September 26, 2024
LETTER OF DENIAL

RE: **691 S Bayview Ave, Freeport, NY**
Zoning District – Residence A Sec. 62 Blk. 187, Lot 13
Building Permit Application #20243871
Description – Construct new (4,829.71SF) 3-story house with attached garage, 2 front balconies (42.6 SF each), 2 rear decks (188.94 SF & 189.09 SF) and maintain hot tub.

COVER SHEET
 SITE PLAN
 ZONING INFORMATION

JOB NO.
 24-43
 SHEET NO.
T-1

PLOT PLAN

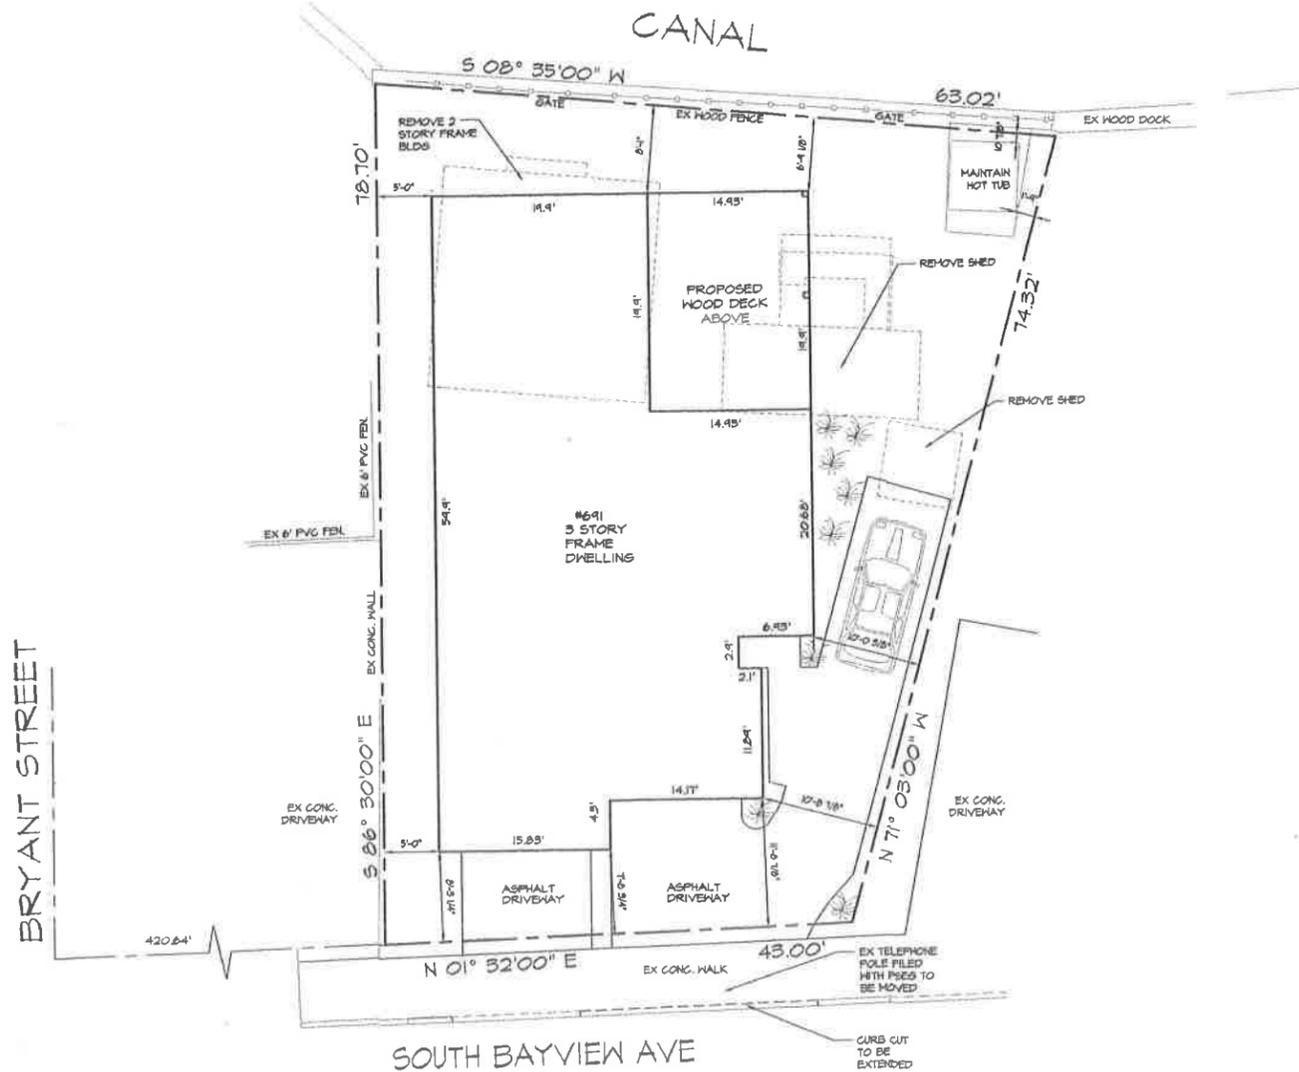
No building shall be erected on a lot whose area is less than 5,000 square feet the drawings submitted indicates that this property is 3,995 SF, you will be seeking a variance of 1,005 SF and on any lot which has a street frontage of less than 50 feet and on any lot whose width is less than 50 feet at a point between the side lines from the front property line to the rear building line of the proposed structure. The drawings submitted indicates that the street frontage is 43'. You will be seeking a variance of 7'.

10% of the total area of the lot may be used for the erection of an accessory building(s) and/or detached garage with the aggregate maximum lot coverage of said accessory building(s) and/or detached garage to be limited to a maximum of 500 square feet, and no more than an additional 5% of the total area of the lot may be used for the erection of an unenclosed porch with the aggregate maximum lot coverage of said porch to be limited to a maximum of 250 square feet. The floor area of the principal building shall not exceed a floor area ratio of 50% of the lot area. The drawings submitted indicates that the lot area is 48.18% when only 30% is permitted. The floor area of the building is 4,892.71 and only 1,997.5 is allowed. You will be seeking a variance of 2,895.21.

(1) Front yard depth: minimum 20 feet or the average depth of all residential front yards on the same side of the street within two hundred 200 feet in either direction, whichever is greater, but in no case more than 40 feet. The drawings submitted indicates that the front yard is 7'-8 3/4" including the attached front decks. You will be seeking a variance of 12'-3 1/4".

(2) Rear yard depth: minimum 20 feet or 20% of the lot depth, whichever is greater, with the exception that for lots abutting canals and other navigable bodies of water, the rear yard depth shall equal the average depths of all residential rear yards abutting the water on the same side of the canal or navigable body of water within 200 feet in either direction or 20 feet measured landwards of the average line of the bulkhead, whichever is greater, or, if no bulkhead exists, measured 20 feet landwards of the rear property line, whichever is greater. The drawings submitted indicates that the rear yard is 6'-9 1/8" including the attached rear decks. You will be seeking a variance of 13'-2 7/8".

(2) Rear yard depth: minimum five feet, except for lots which abut canals or navigable waters, a minimum depth of 20 feet measured landwards of the average line of the bulkhead shall be provided; if no bulkhead exists, measured 20 feet landwards of the rear property line. The drawings submitted indicates that the hot tub is 10" off the bulkhead. You will be seeking a variance of 19'-2" for the hot tub.
